RB290-22

Proposed Change as Submitted

2021 International Residential Code

Tee Fitting Clogged with Concrete and Tee Fitting Filled with Gravel

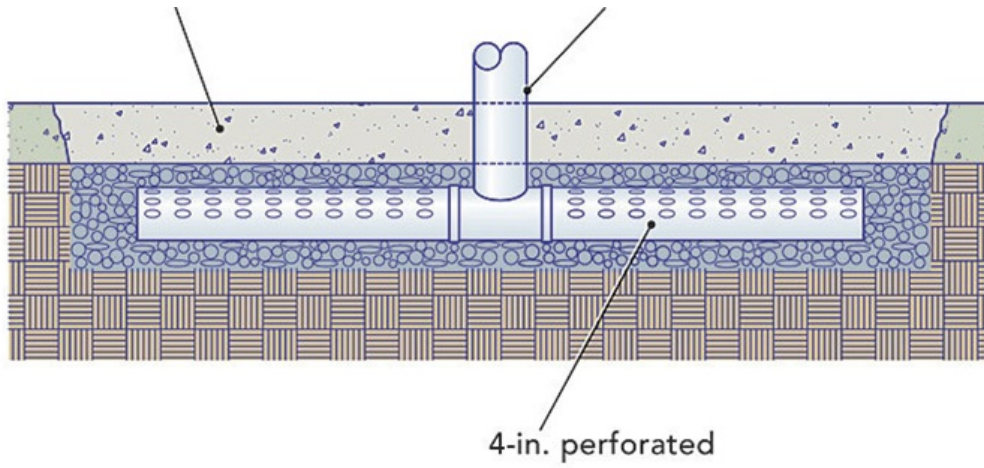
Commenter's Reason: This is a very common problem in the field where concrete from the slab pour leaks past the soil retarder and fills the "Tee Fitting". Gravel can also close off the "Tee Fitting" openings. Adding the pipe extenders keeps the suction point open.

Extending the Tee Fitting with perforated pipe prevents closure of the suction point. This is a minimal cost to the builder.

AF103.6.1 Subslab Vent pipe. A minimum 3-inch-diameter (76 mm) ~~ABS, PVC or equivalent~~ gastight pipe shall be embedded vertically into the subslab aggregate or other permeable material before the slab is cast. A "T" fitting or equivalent method shall be used to ensure that the pipe opening remains within the subslab permeable material. Not less than 4 feet (102 cm) of perforated pipe or geotextile matting shall be connected to each of the horizontal openings of the tee fitting. Alternatively, the 3-inch (76 mm) pipe shall be inserted directly into an interior perimeter drain tile loop or through a sealed sump cover where the sump is exposed to the subslab aggregate or connected to it through a drainage system. The pipe shall be extended up through the building floors, and terminate not less than 12 inches (305 mm) above the surface of the roof in a location not less than 10 feet (3048 mm) away from any window or other opening into the *conditioned spaces* of the building that is less than 2 feet (610 mm) below the exhaust point, and 10 feet (3048 mm) from any window or other opening in adjoining or adjacent buildings. All above ground material used shall comply with Section P3002.1.

FIGURE AF101.1 EPA MAP OF RADON ZONES

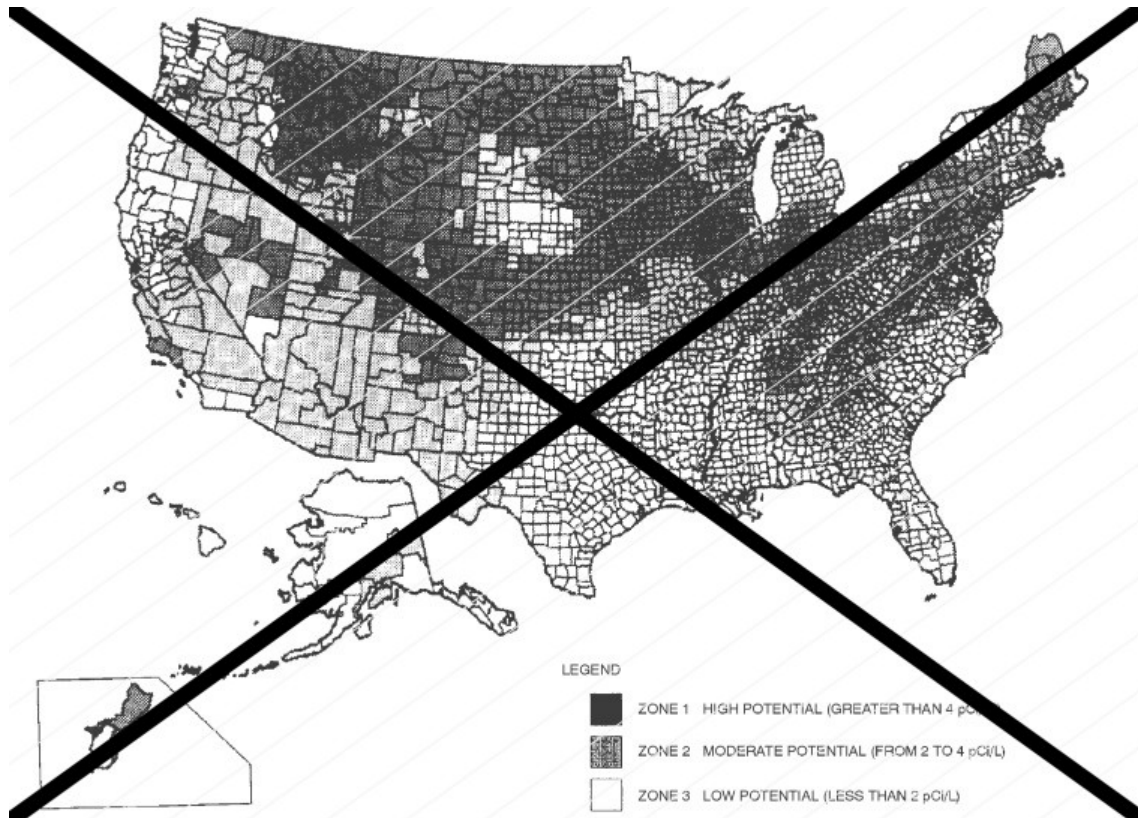
Reason: The EPA map and Zone 1 county list are based in part on a 1993 survey that measured radon in 5694 homes, less than two per each of the 3141 counties in the US. As more recent data have been compiled by states and the US Centers for Disease Control and Prevention, it is evident that more counties' average radon test results equal or exceed the EPA action level.

Radon Zone 1 counties are defined as having a predicted year-round average indoor radon screening level in the lowest livable area of a structure greater than or equal to four picocuries per liter of air (pCi/L). Relying on an average radon level does not address the full range of risk within a given county. Levels greater than 4 have been found in 85% of US counties tested.

In response to stakeholder feedback EPA has been deemphasizing the use of the EPA zone map as a reference for building codes and specifications. The purpose of the EPA radon zone map, since its inception, has been to show potential of risk not ACTUAL risk. While it is still a useful tool, it unintentionally creates a false sense of security for those in Zone 2 and Zone 3 that risk in those areas is non-existent. With this in mind, the EPA Indoor airPLUS program (a voluntary partnership and labeling program that helps new home builders improve the Indoor Air Quality) plans to include testing in ALL ZONES in its upcoming Version 2 update. The fact remains that radon is found in all zones and to truly protect against radon you need to test regardless of zone.

AF101.1 General. This appendix contains requirements for new construction ~~in jurisdictions~~ where radon-resistant construction is required. ~~Inclusion of this appendix by jurisdictions shall be determined through the use of locally available data or determination of Zone 1 designation in Figure AF101.1 and Table AF101.1.~~

Delete without substitution:
